CITY OF RIVERSIDE, CALIFORNIA
DEPARTMENT OF PUBLIC WORKS

ALLEY PLAN & PROFILE
LOTS F & G
TRACT 2350
HORIZ. SCALE 1"=40' VERT. SCALE 1"=4'

STREET PLAN & PROFILE
LINDEN STREET
Sta. 6+89.77 to Sta. 13+82.54
TRACT 2350
HORIZ. SCALE 1"=40' VERT. SCALE 1"=4'

STREET PLAN & PROFILE
RUSTIN AVENUE
TRACT 2350

ALLEY PLAN & PROFILE
LOTS E & H
TRACT 2350

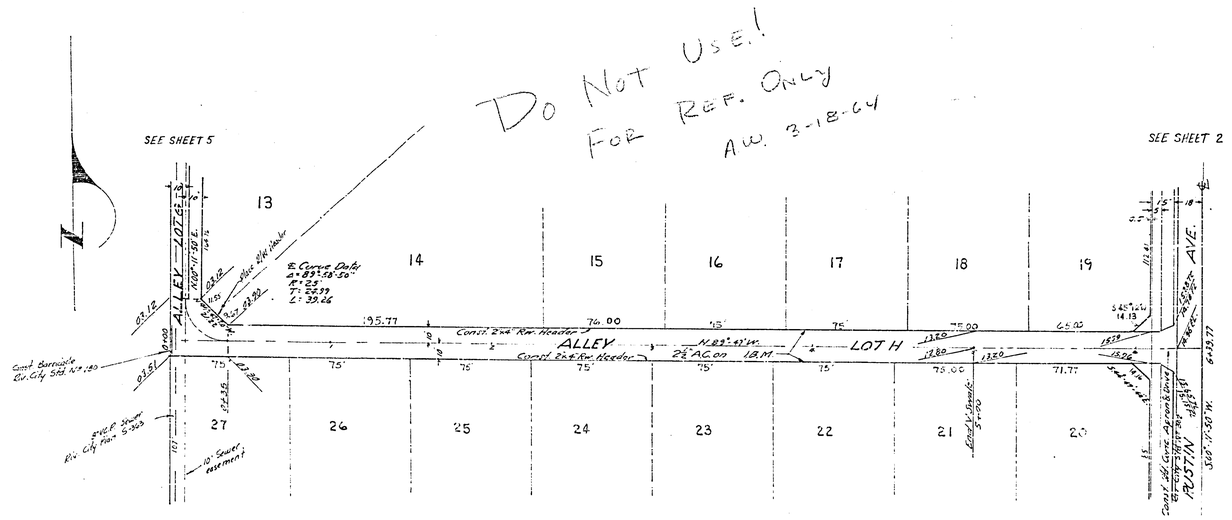
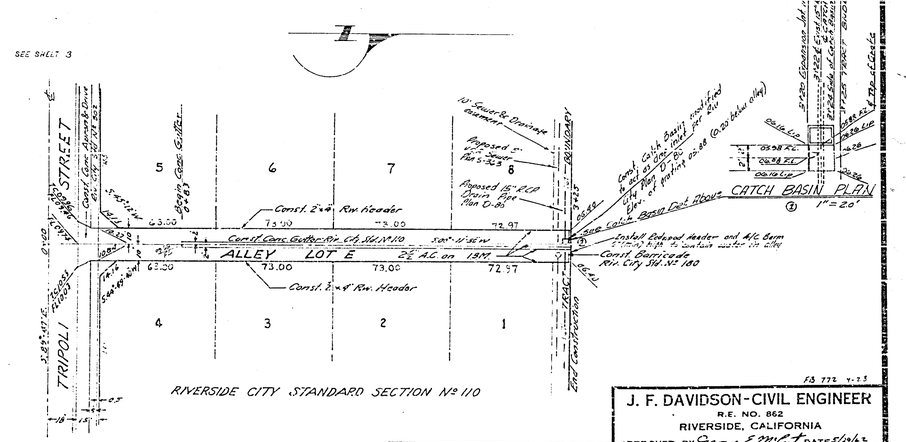
REVISIONS		
MARK	DATE	DESCRIPTION
4	9/12/63	Revised Gutter to meet existing Catch Basin.

ALLEY PLAN & PROFILE
LOTS E & H
TRACT 2350
HORIZ. SCALE 1" = 40' VERT. SCALE 1" = 4'

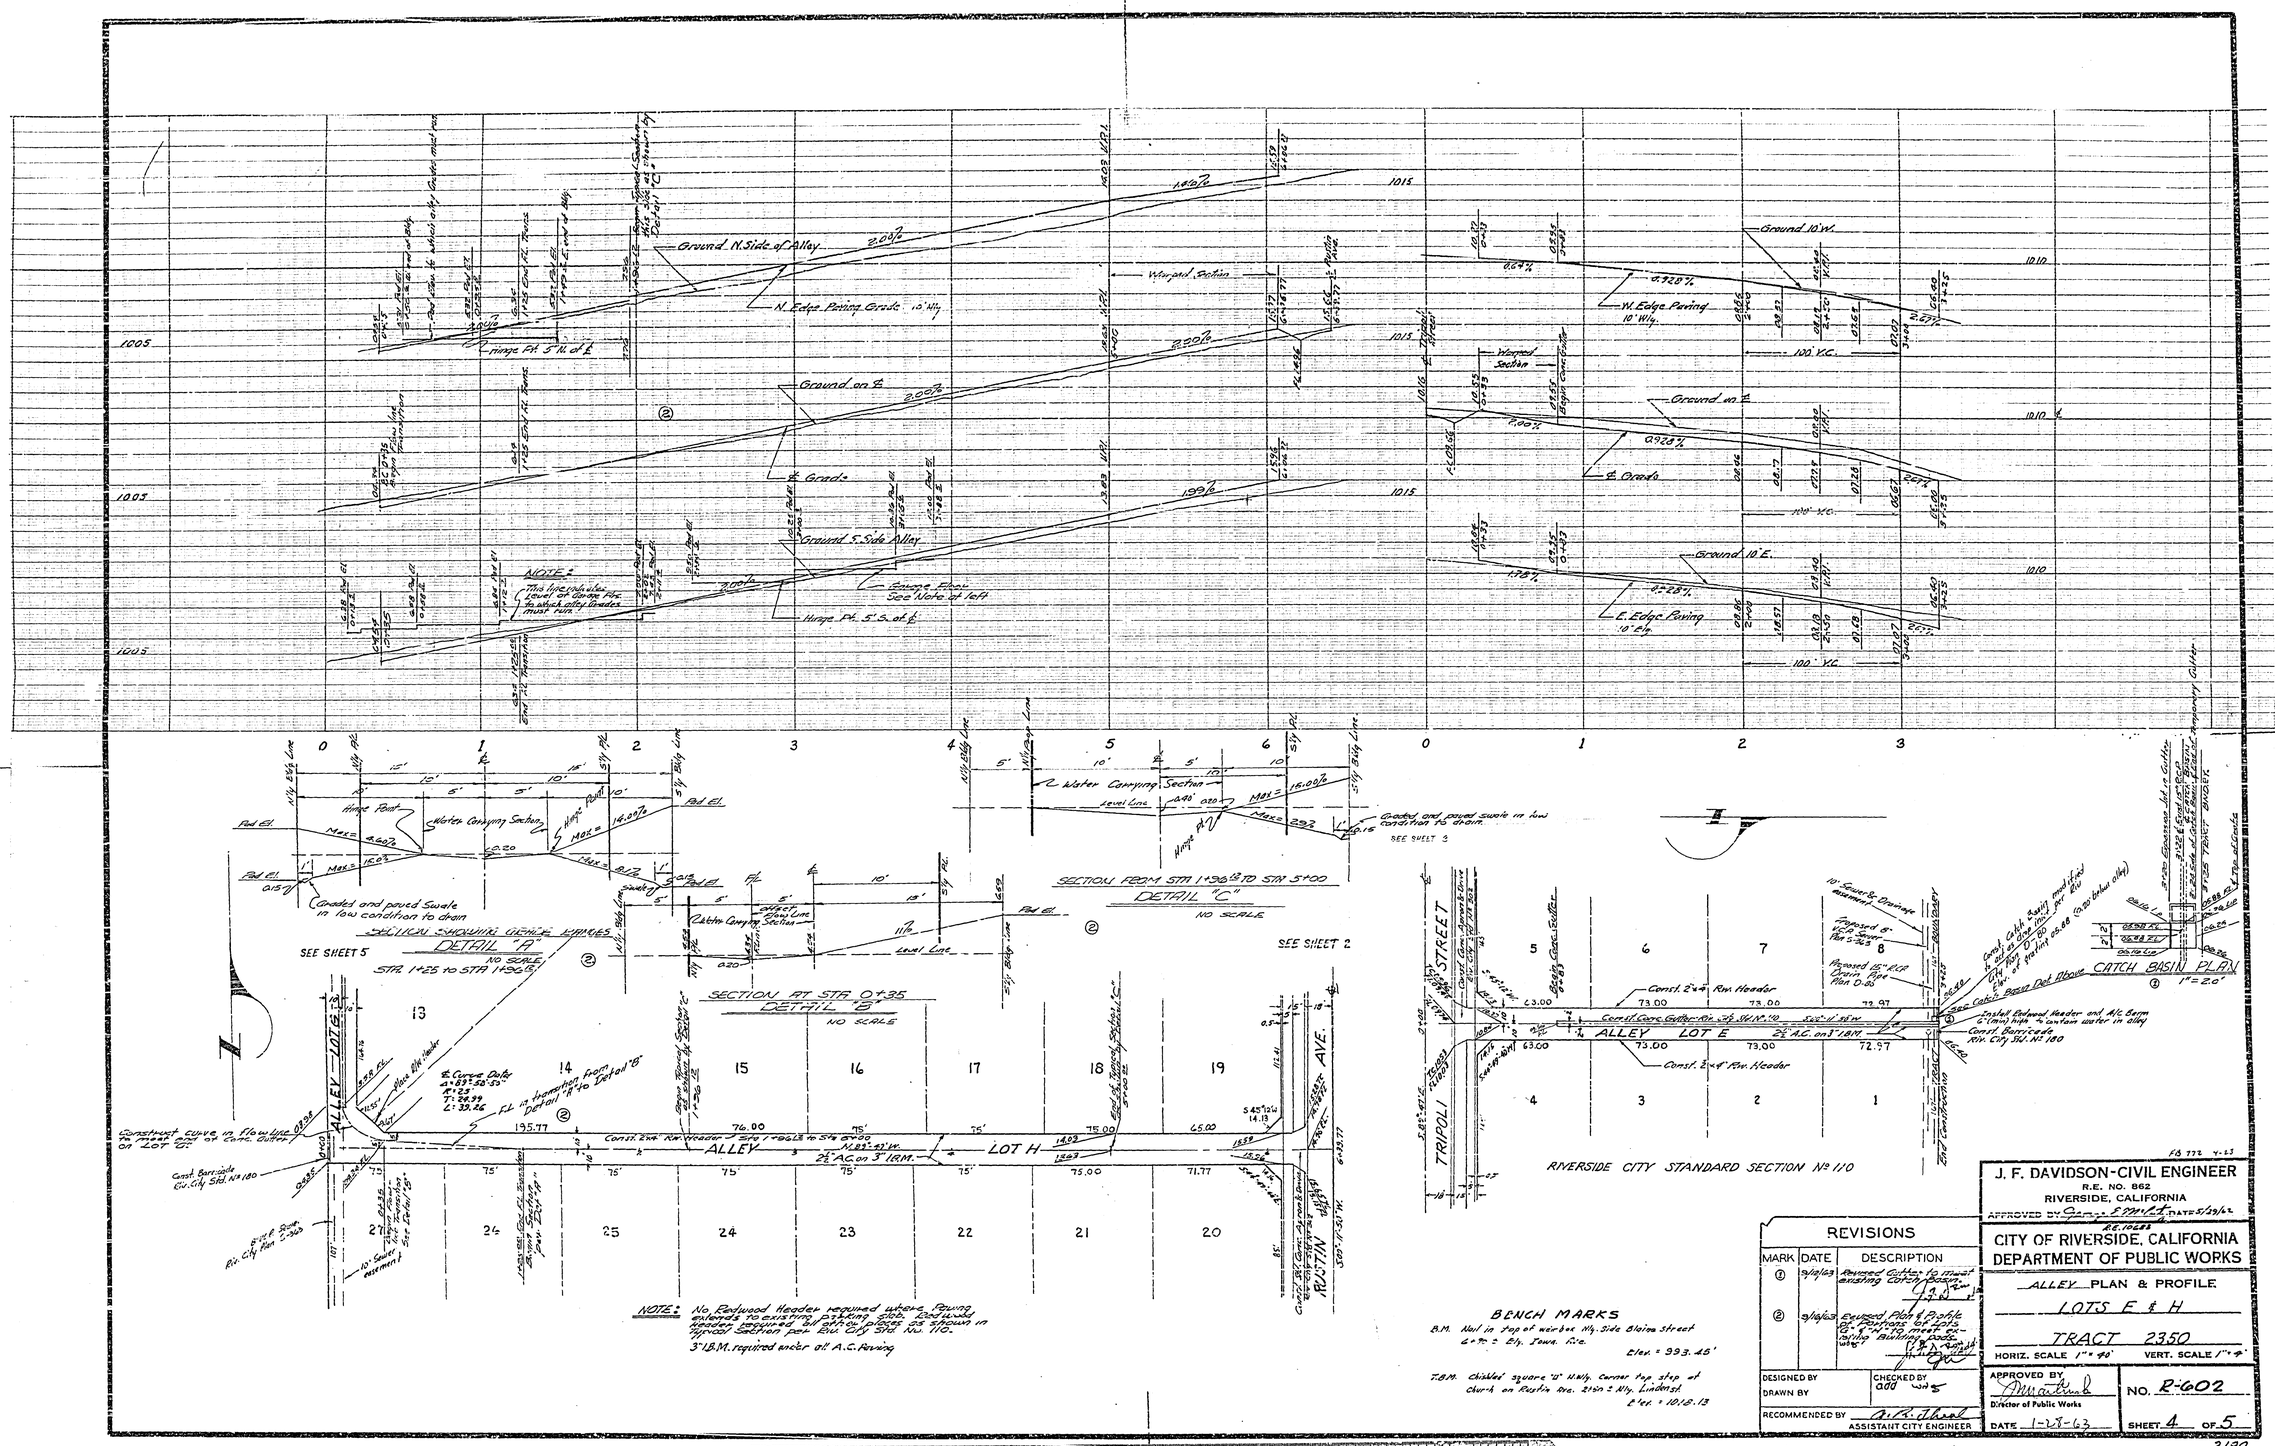
REVISIONS		
MARK	DATE	DESCRIPTION
①	9/10/63	Revised Gutter to meet existing Catch Basin.
②	9/10/63	Revised Plan & Profile of Portions of Lots "G" & "H" to meet existing Building pads.

ALLEY PLAN & PROFILE
LOTS F & G
TRACT 2350

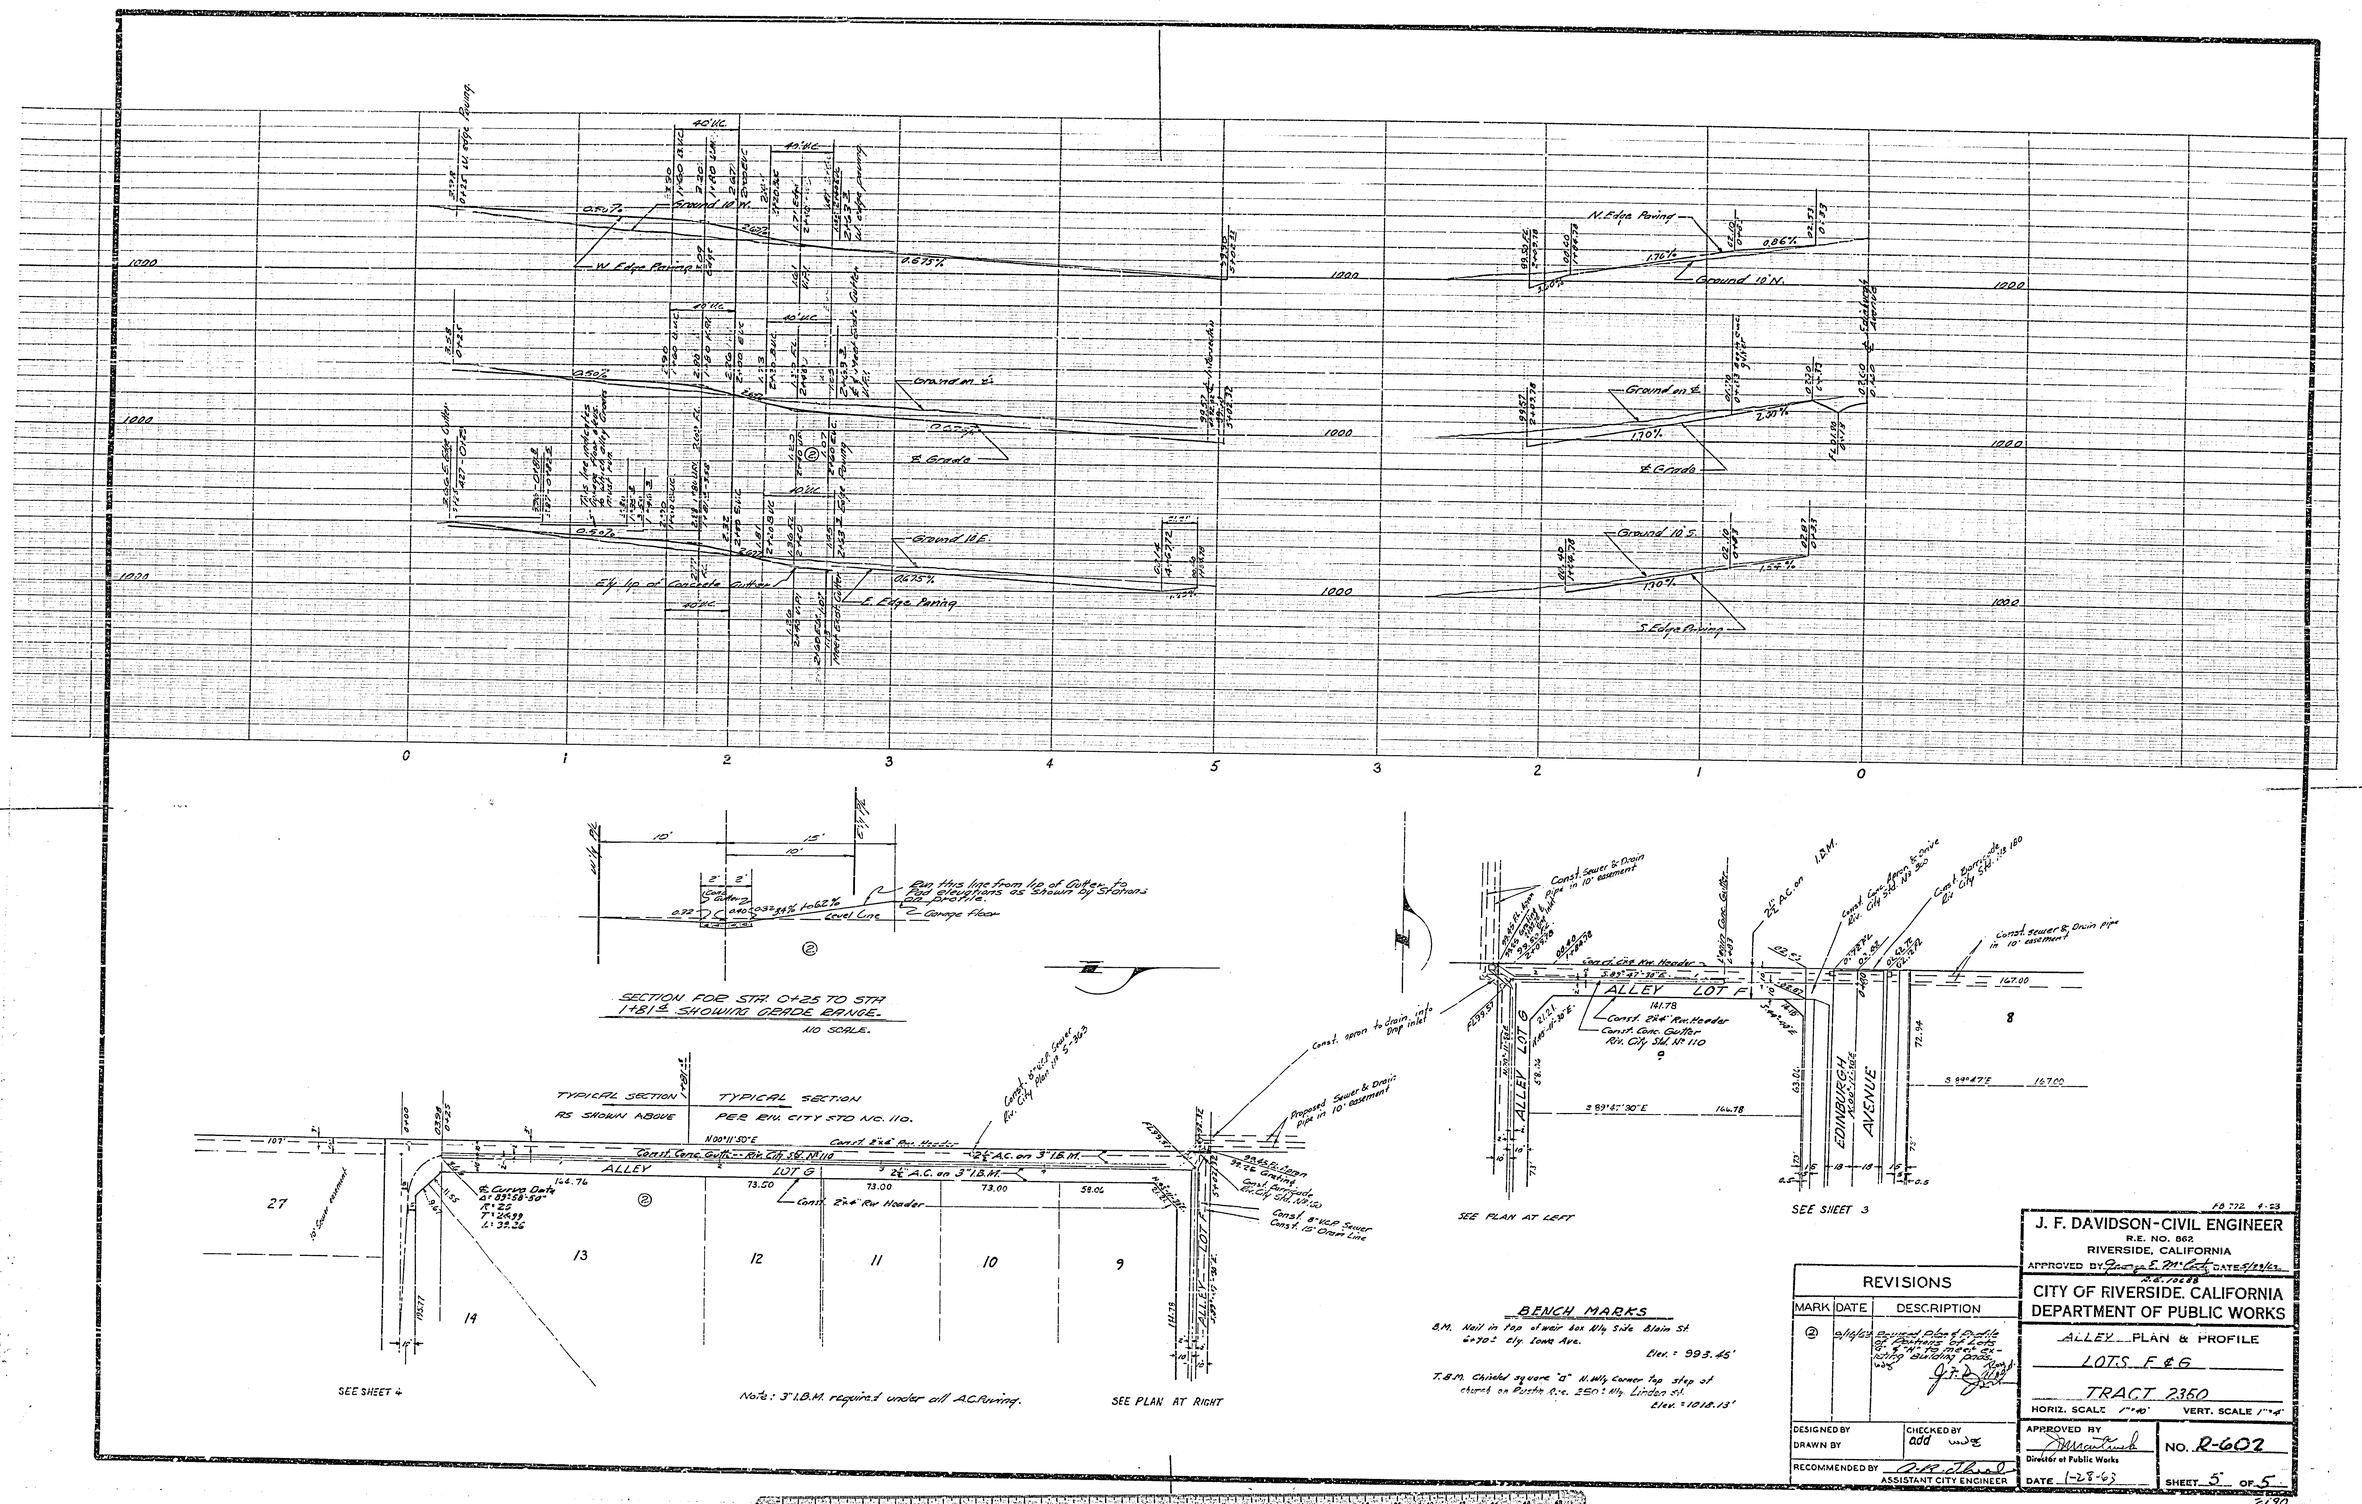
REVISIONS		
MARK	DATE	DESCRIPTION
2	5/19/63	Revised Plan & Profile to Contours on Lots 8 & 9 to meet existing building pads.

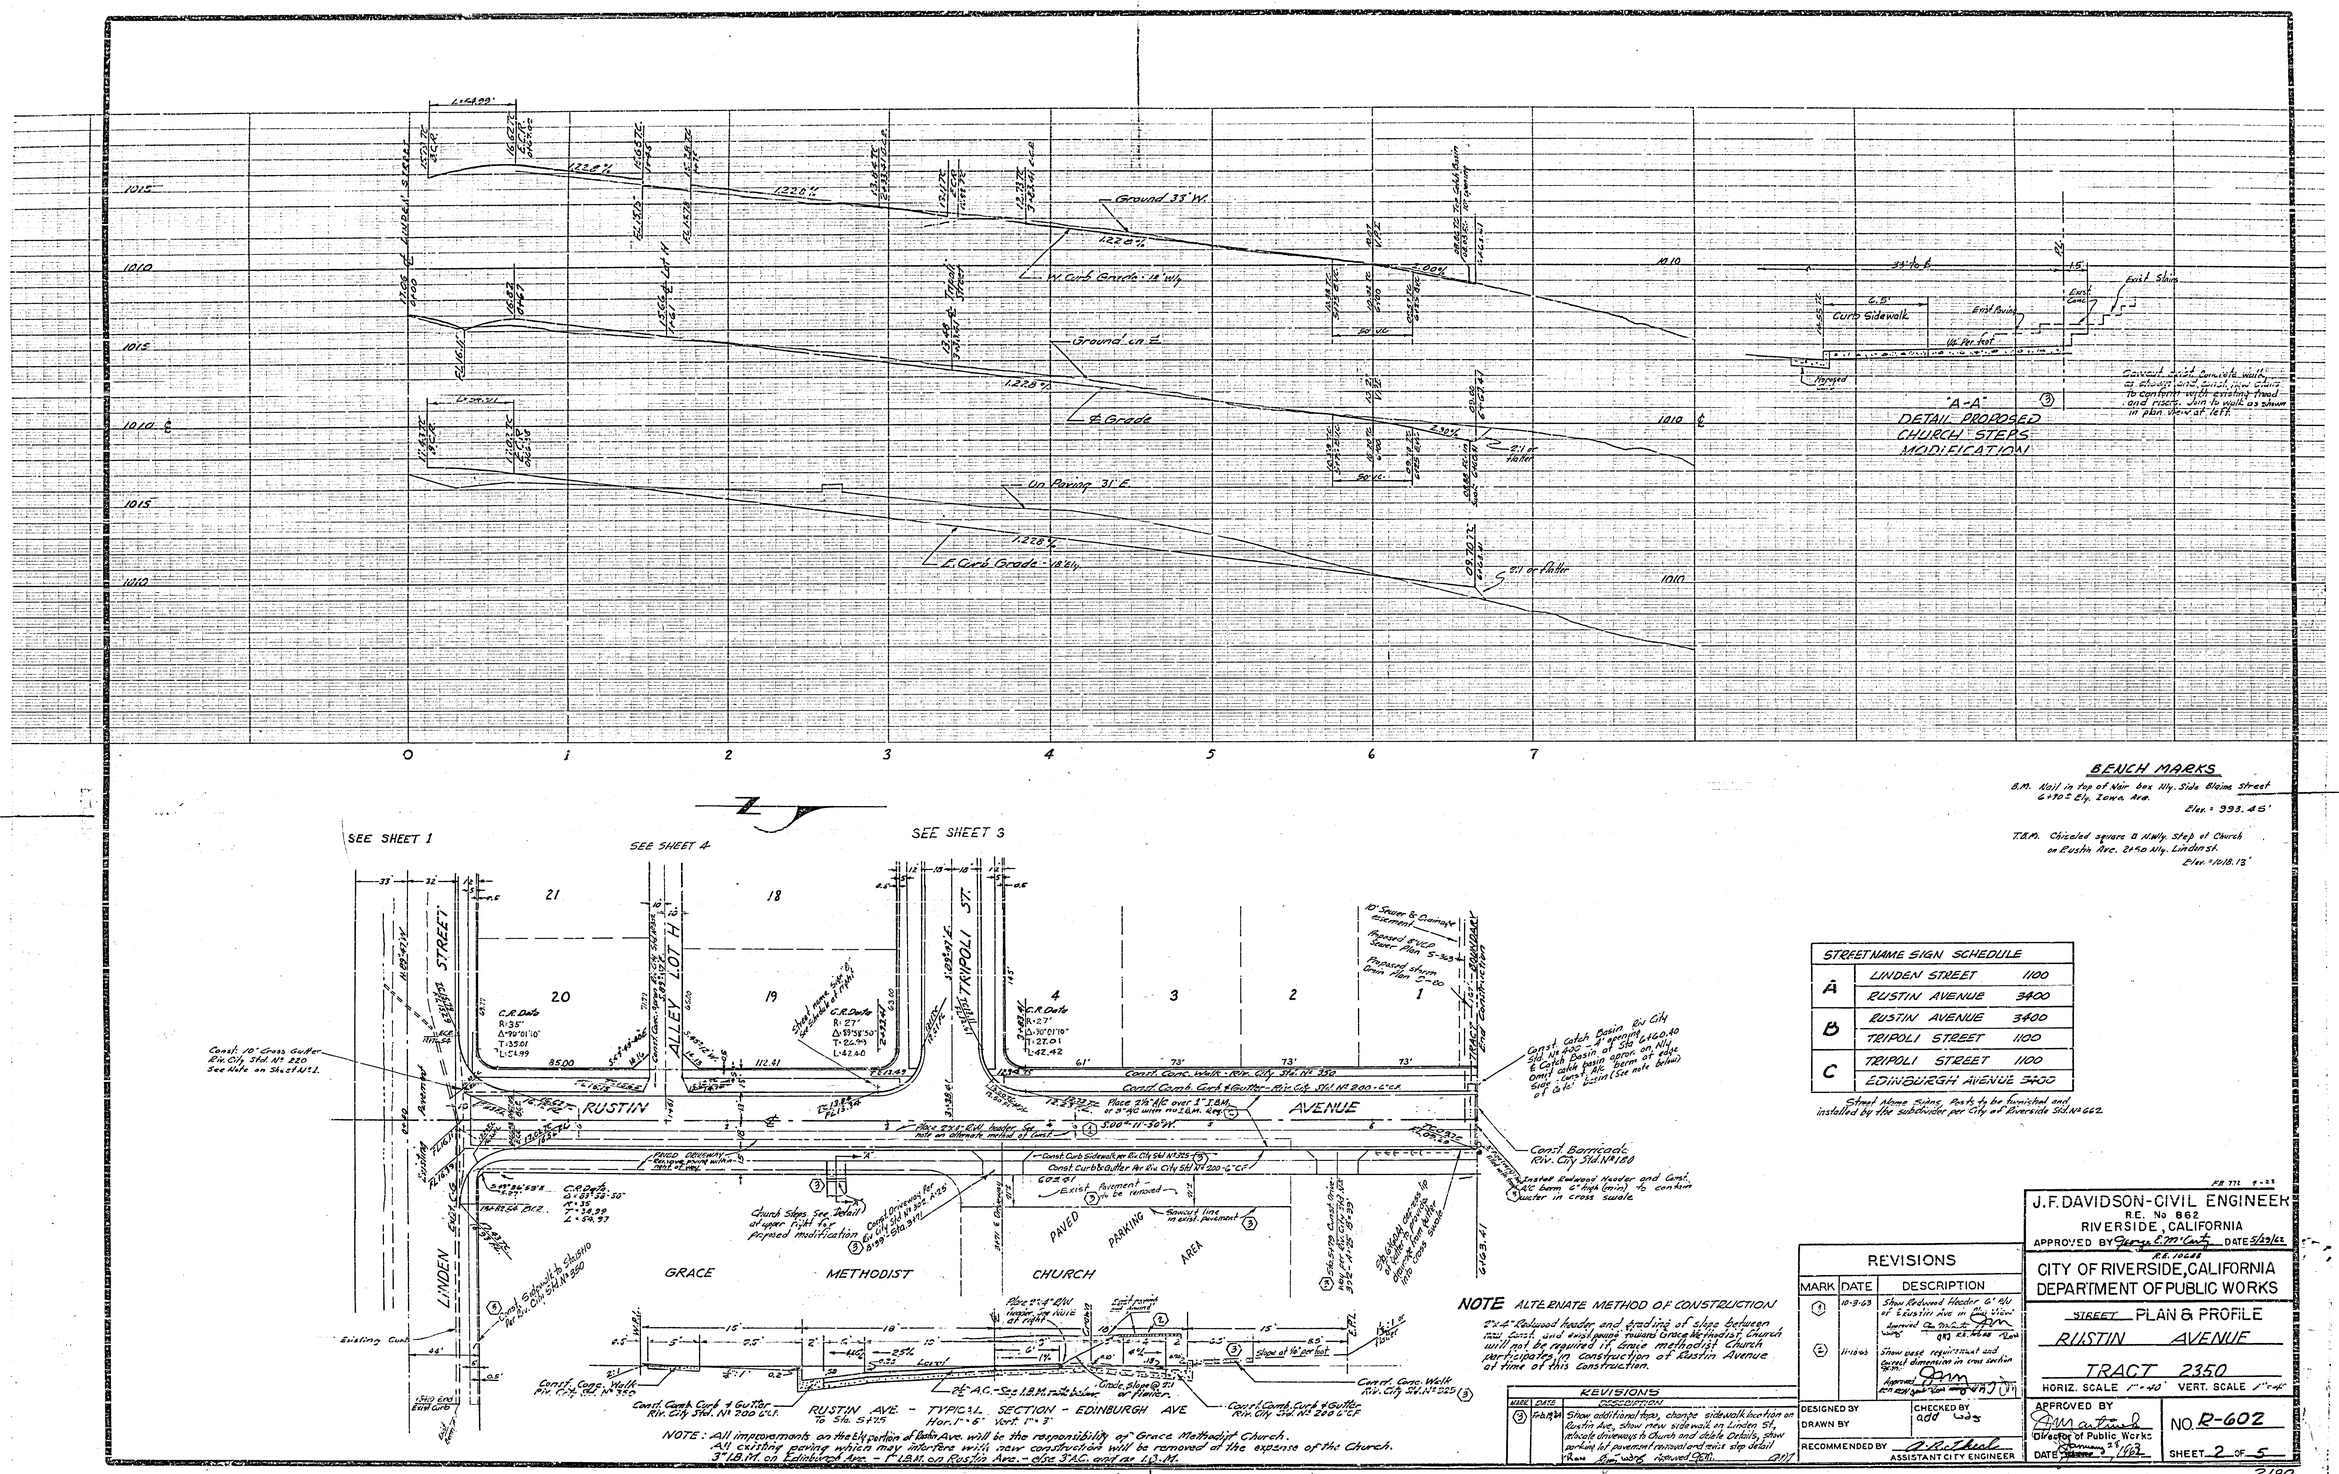
REVISIONS		
MARK	DATE	DESCRIPTION
4	10-3-63	Show Redwood Header 6" N'ly of ℄ Rustin Ave in Grace Methodist Church Area. Approved as to C.E. Plan by [illegible]
5	11-18-63	Show west requirement and correct dimensions in cross section. Approved as to C.E. Plan by [illegible]

REVISIONS		
MARK	DATE	DESCRIPTION
3	7-8-64	Show additional topo, change sidewalk location on Rustin Ave, show new sidewalk on Linden St, relocate driveways to Church and add details, show parking lot pavement removal and new slip detail. Plan & Prof. work approved [illegible]
